A G E N D A

Architectural Review Board

June 27, 2017

1570 South Perry Street

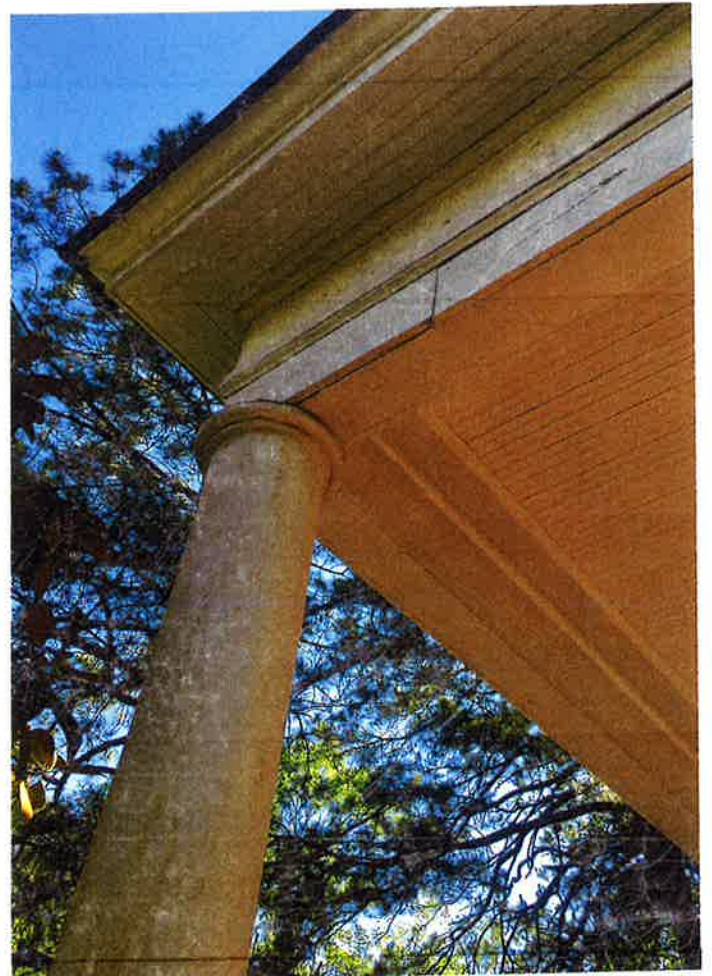
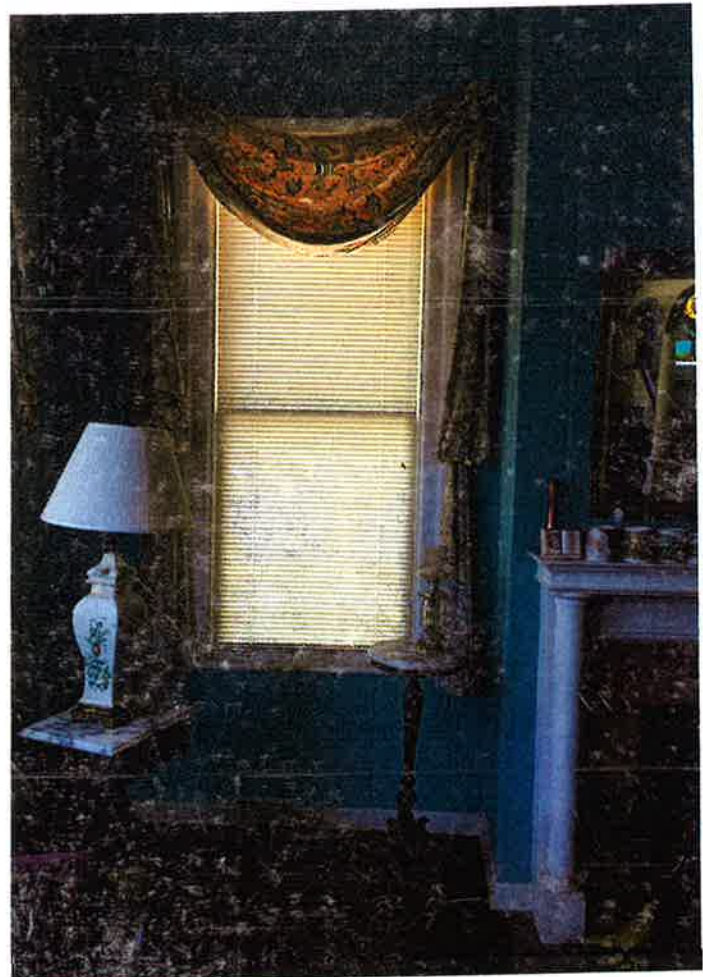
- It is the staff opinion that the porte cochere is an original feature of the house, although various repairs have altered the materials (brick base and columns). Ceiling is bead board, all trim is wood with sizing and details consistent with early 20th century houses. There are several other similarly detailed houses on the street (see photos) that also have porte cocheres. The 1953 Sanborn map shows the open under roof extension in this location, and the presence of an exterior light switch that was not covered with aluminum siding seems to indicate at some point a door was located in this wall—either in place of one of the windows, or as staff recently discovered removing aluminum siding off another house, just sided over on the exterior and walled over on the interior.

- The structural report provided seems to indicate the deterioration is due to water, may be isolated, is likely due to the wrong roofing material being applied to a low slope, and can be repaired.

- The Board is reminded that the question before you is whether or not this is a character defining feature of the house and is it a feature that needs to be retained, not what the cost of repair/reconstruction might be.

668 Ponce de Leon

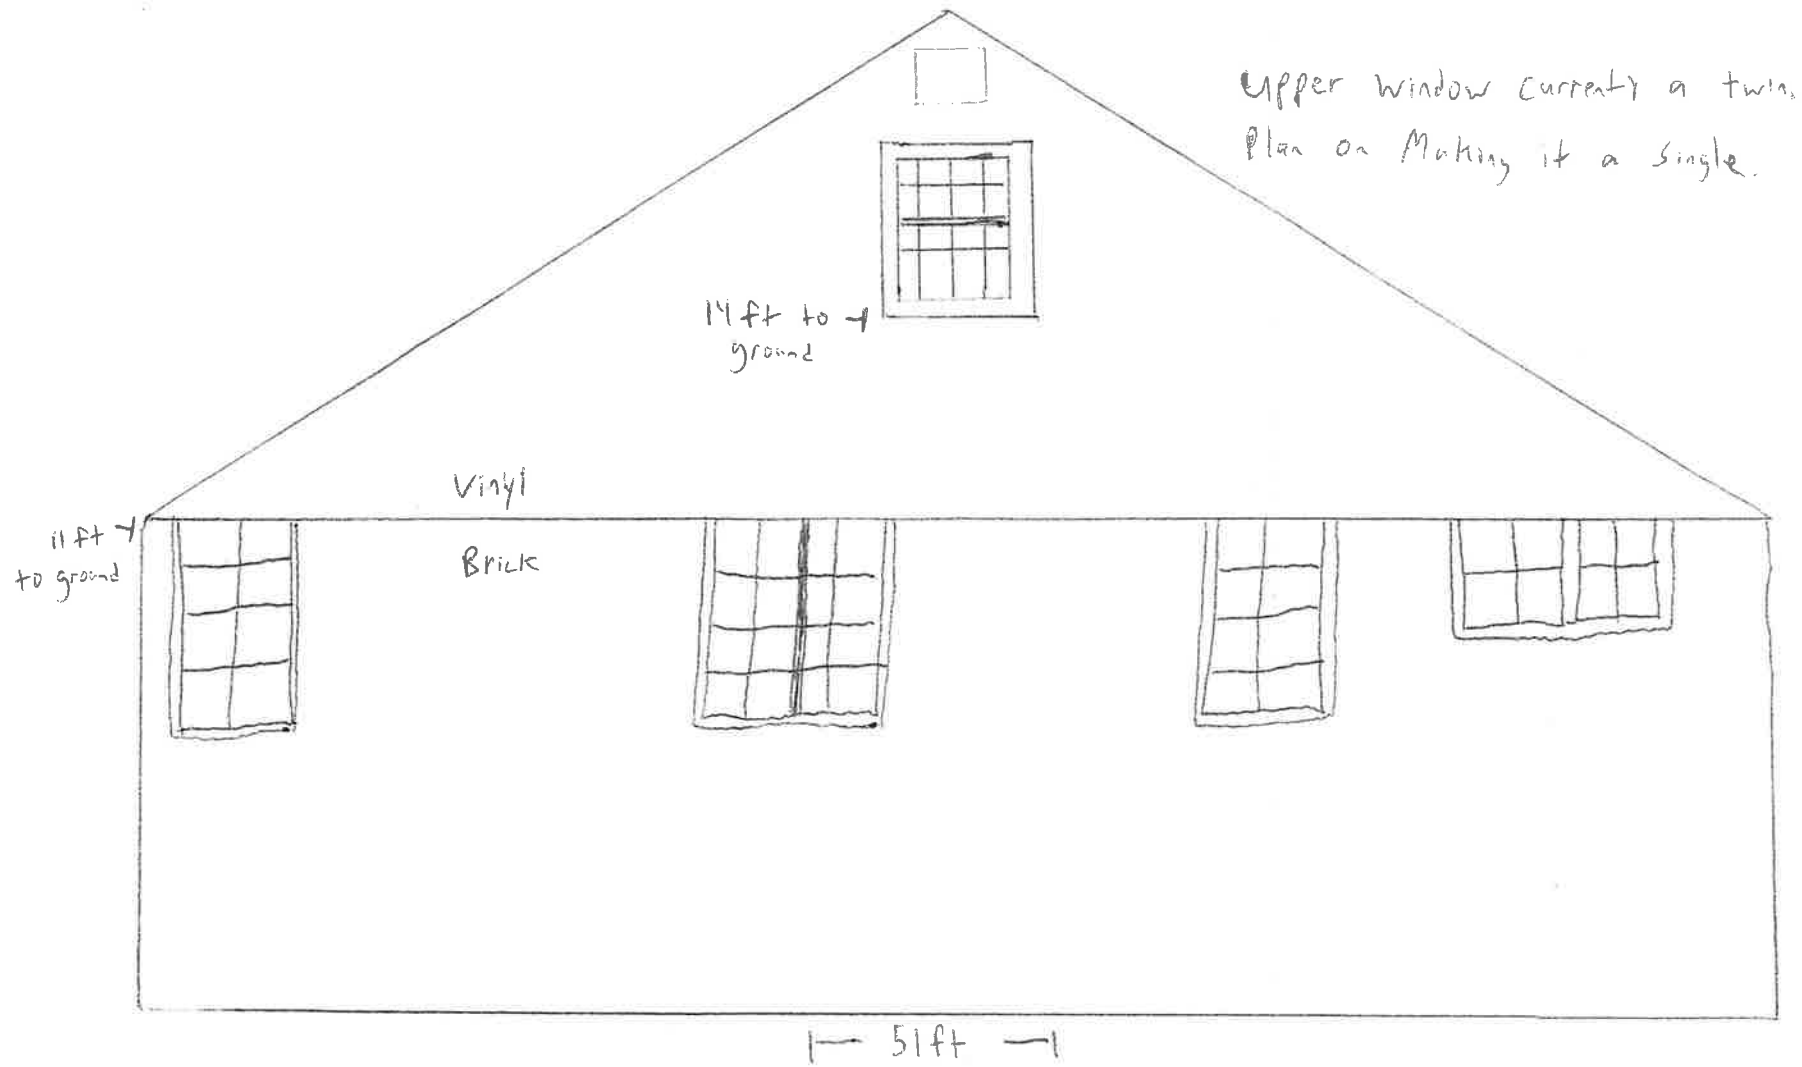
- The window that is installed in the gable appears to be vinyl as well as the siding.

1211 Westmoreland Avenue

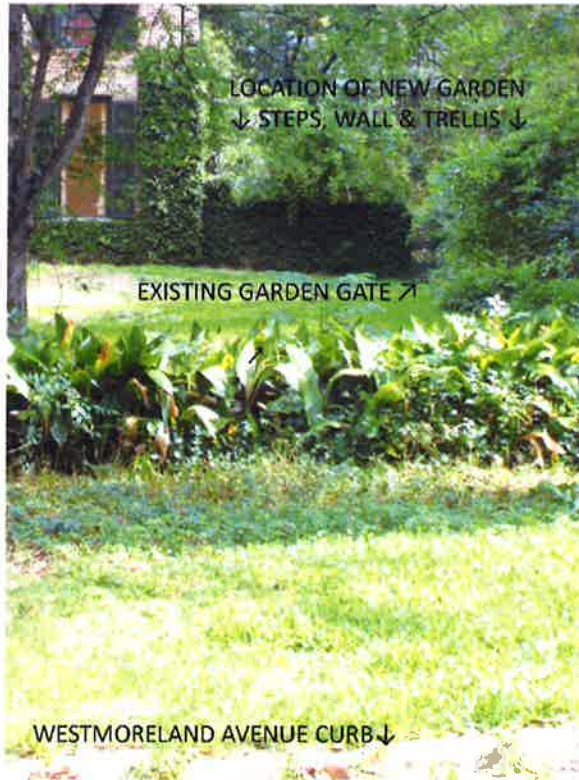
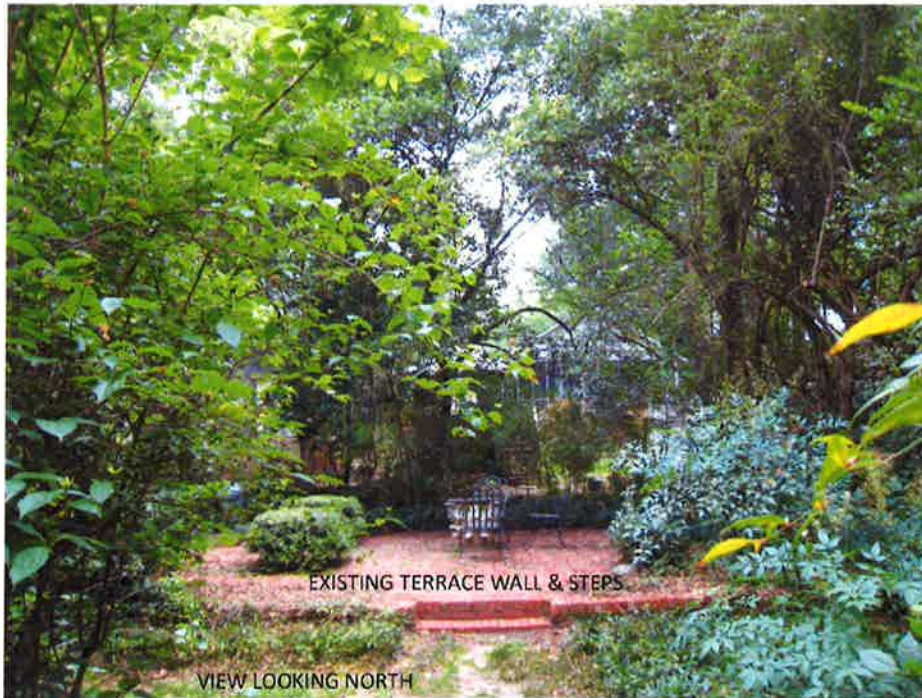
- Project does not appear to adversely affect the adjacent tree.
- See separate oversized drawings

SHEET TITLE
NEW FLOOR PLAN

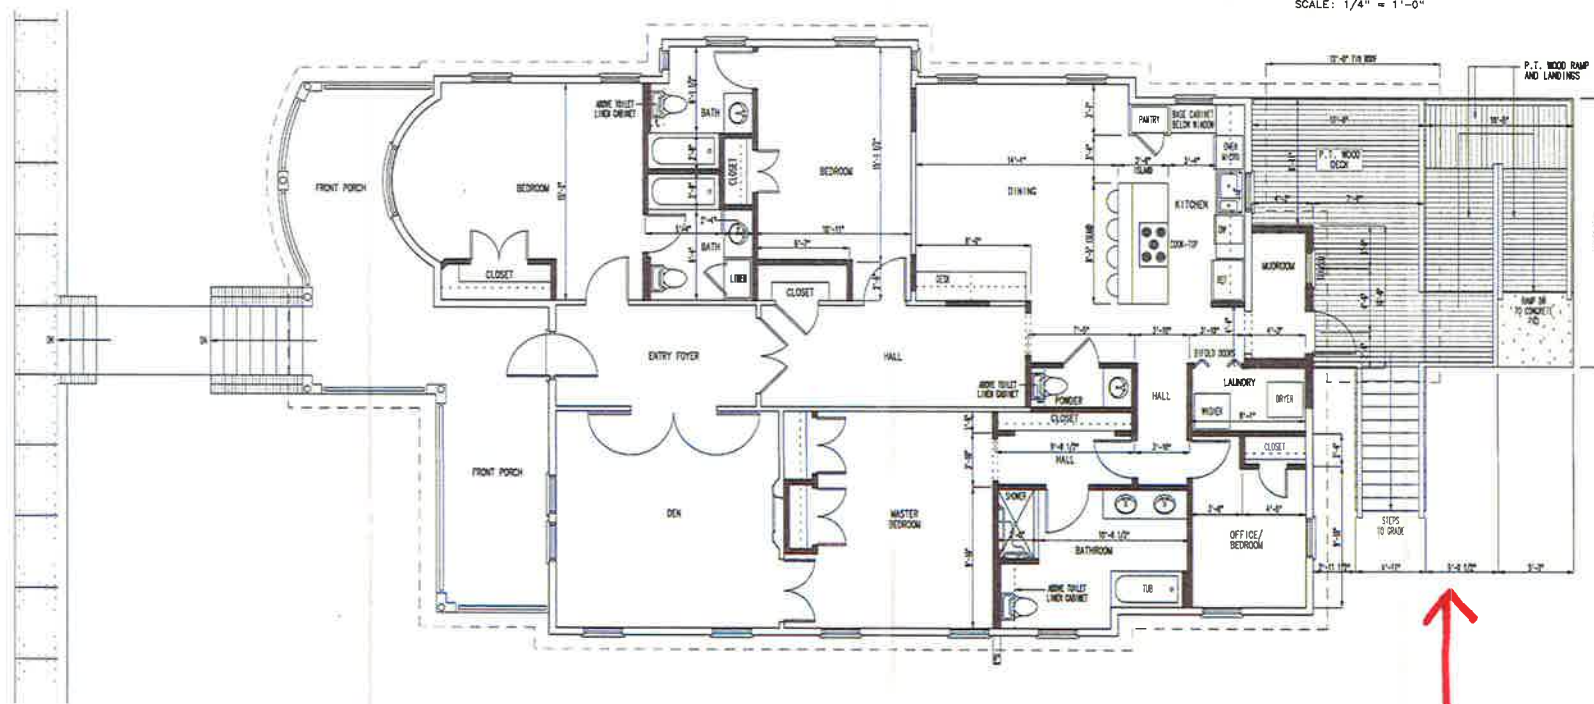
- The Board has routinely approved rear decks, all work will avoid the large tree in the photo.
- Full sized plan will be available at the meeting
